Project Name: DELVA RESIDENCE ONE STORY ADDITION

DENIAL TO THE ZONING BOARD OF APPEALS

DELUCA RESIDENCE ONE-STORY ADDITION

PLOT PLAN SCALE: 1" = 20'

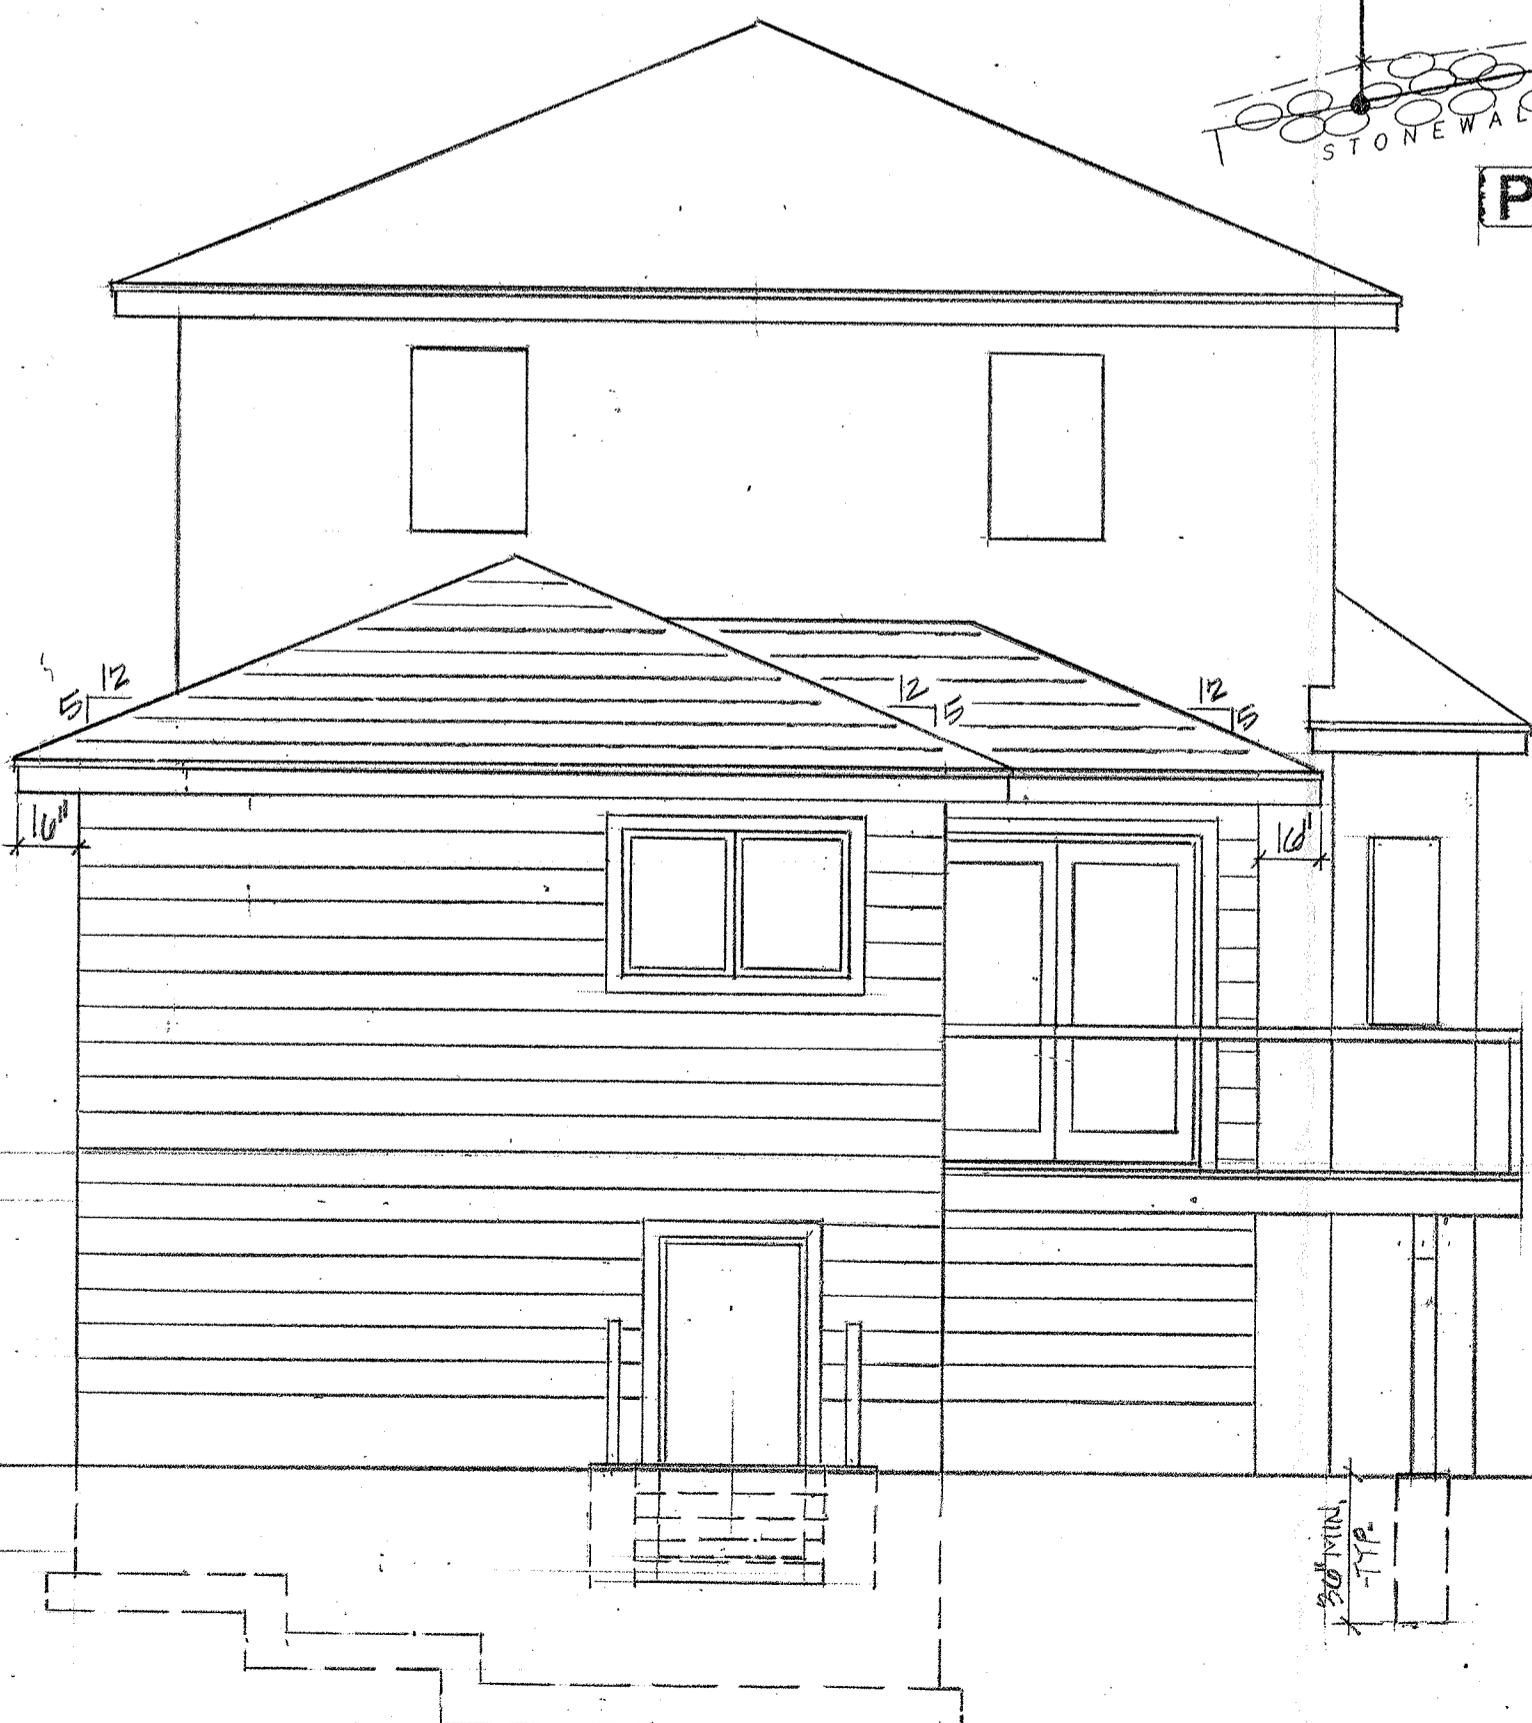
Chapter 43, 3.12 Table, Column 1 RG District, Column 9 Required Minimum side Yard 10' with 8' proposed.

Existing non-Conforming Side Yard for house 9.6'

Chapter 43, Section 5.21 Undersized lot applies

Chapter 43 Table 3.12 Column 1 R.G. District, Column 9, Minimum Required Side Yard 10' w/ 8' proposed. Existing Non-Complying Main House Side Yd. 9.6'. Chapter 43, Section 5.21 Applies
, Variances Req'd.
